# WARRANTY BULLETIN

**WB23-38**

| SUBJECT :   | <b>UREA HARNESS REPLACEMENT</b> |           |               |

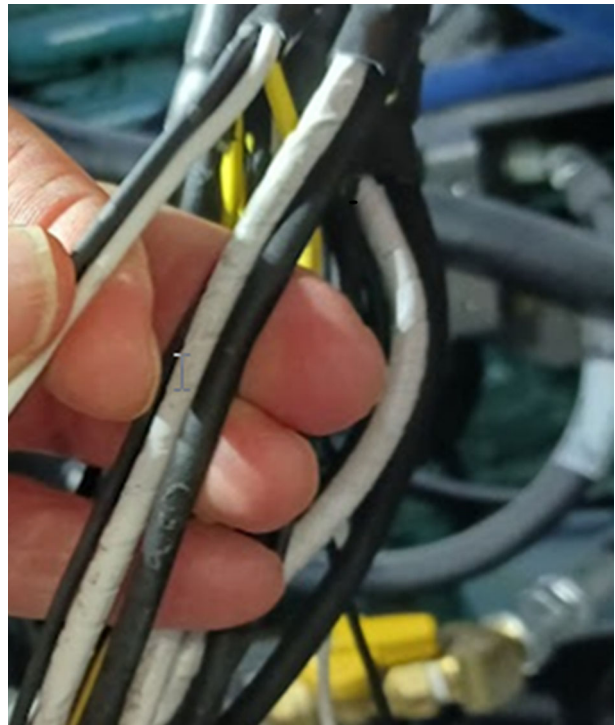
5. Remove eight inches of the loom from connector A137A.
6. Verified if you have wire with a splice see the picture.
- If yes, go to the next step.
  - If no, reinstall the loom and secure the cable to complete the procedure.

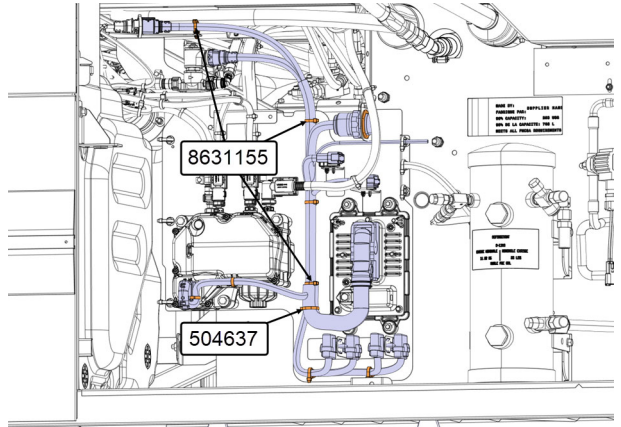
9. Install the new urea harness 0610591.
10. Secure the harness using cable ties 8631155 (10x) and 504637 (5x).
